ADDENDUM No. Three (3)

IFB No. 2020-272

CONSTRUCTION, NEW OFFICE BUILDING FOR PRECINCT 2
JUSTICE OF THE PEACE & CONSTABLE

Architect's Addendum Number Three

LAVON PCT 2 LIFT STATION

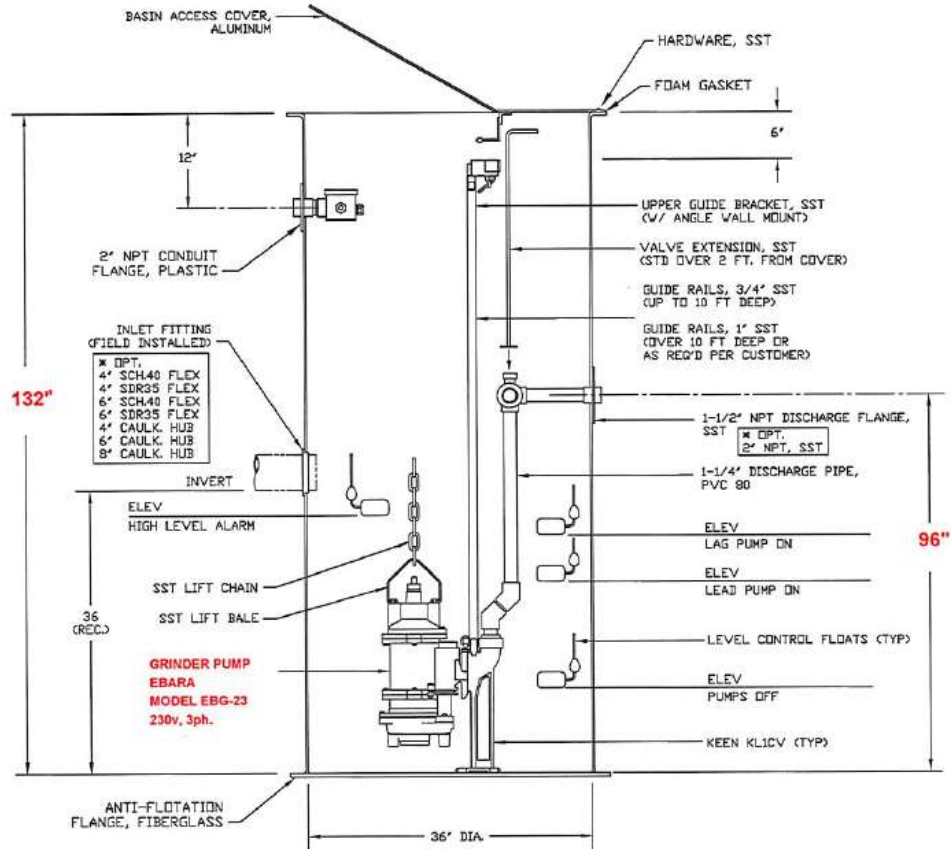
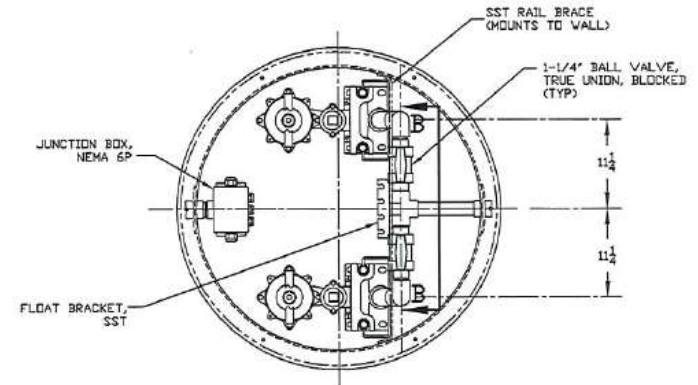
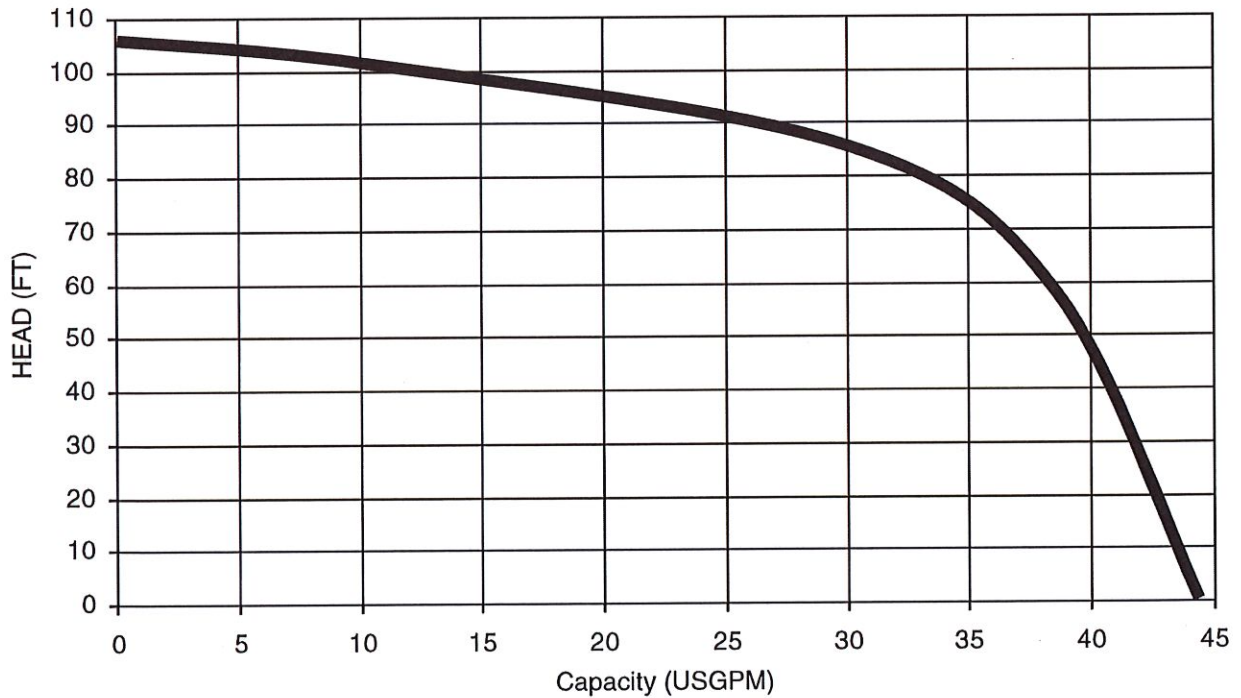
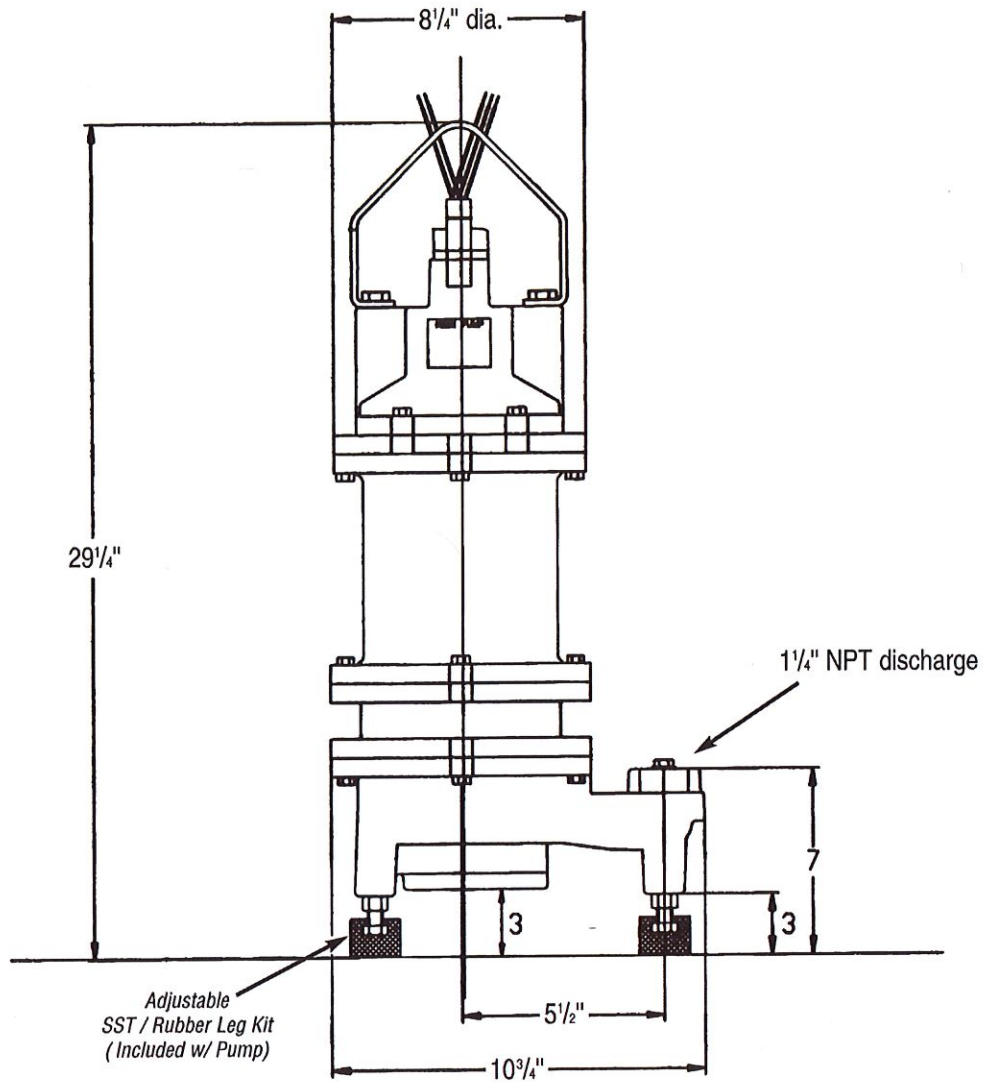
36	Please provide a specification for the Lift Station required for the sanitary sewer	Refer to Architect's Addendum No Three, Item 1 and Lift Station Design Concept attachment.
37	Please provide a specification for the lift station.	Refer to Architect's Addendum No Three, Item 1 and Lift Station Design Concept attachment.
38	On sheet C5-1 there is a Lift Station listed to be installed but there is not a detail shown on the plans for this item. Please advise.	Refer to Architect's Addendum No Three, Item 1 and Lift Station Design Concept attachment.

Item 1: Clarification: Refer to attached Lift Station Design Concept for design drawings, equipment lists, etc. regarding Lift Station shown on Civil Drawings SP, C2-1, C5-1 and C5-2.

- 1- Ebara Duplex Packaged grinder pump station containing:
 - * (2) EBG-23 submersible grinder pumps, 2HP, 230/3/60, dual seal, 3450 RPM
 - * KL1CV Lift out system, integral check valve with stainless steel upper brackets, 1 inch guide rails, and lift chains
 - * Sch. 80 PVC discharge piping, ball valve with stainless steel extension handles, 36" depth
 - * Junction Box, stainless steel float bracket, and (4) float switches
 - * 4 inch flexible inlet (shipped loose)
 - * Nema 4X alternating control panel with alarm light and buzzer with test/silence, pump run and seal leak lights, hand off auto switches
 - * 36x 132" Fiberglass basin with aluminum access cover
- 1- Item Freight to Jobsite
- 1- Item Field Start-up Supervision

**FIRST FLOOR
POWER PLAN**
SCALE: 1/4" = 1'-0"

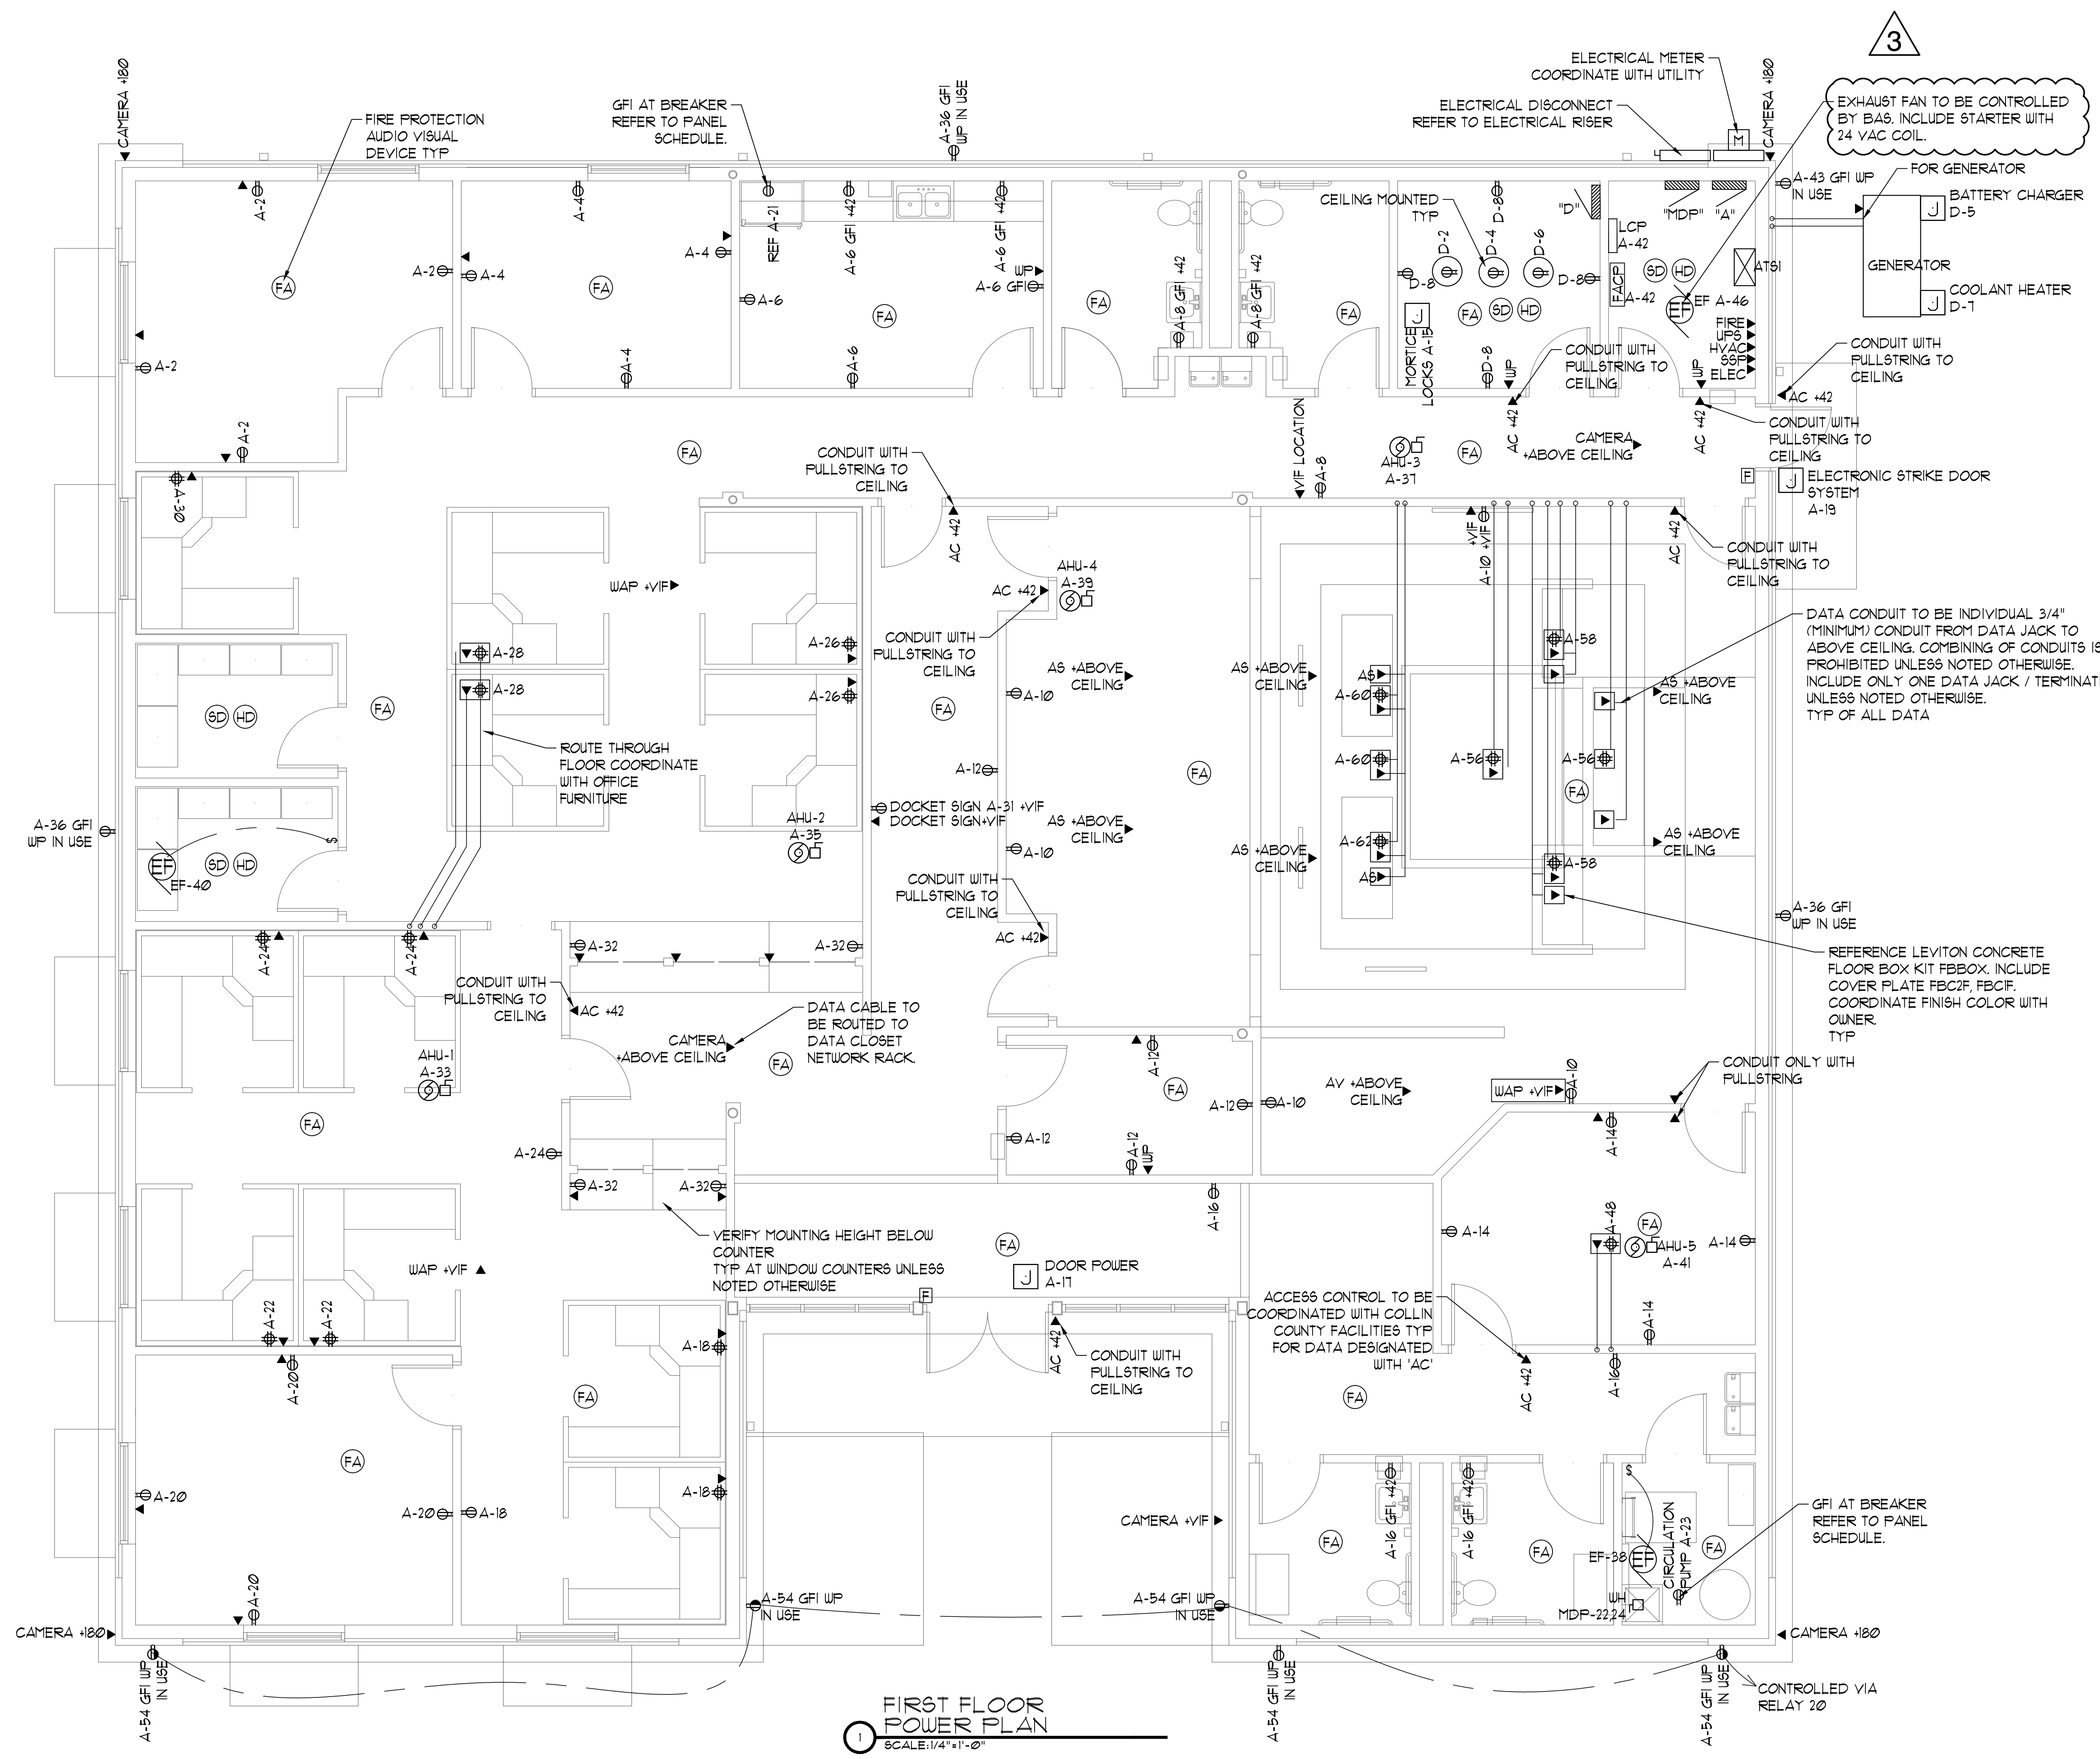
Item 2: Revision: Refer to attached MEP Drawings M1, M3, M4 and E2 for revisions to HVAC Controls.
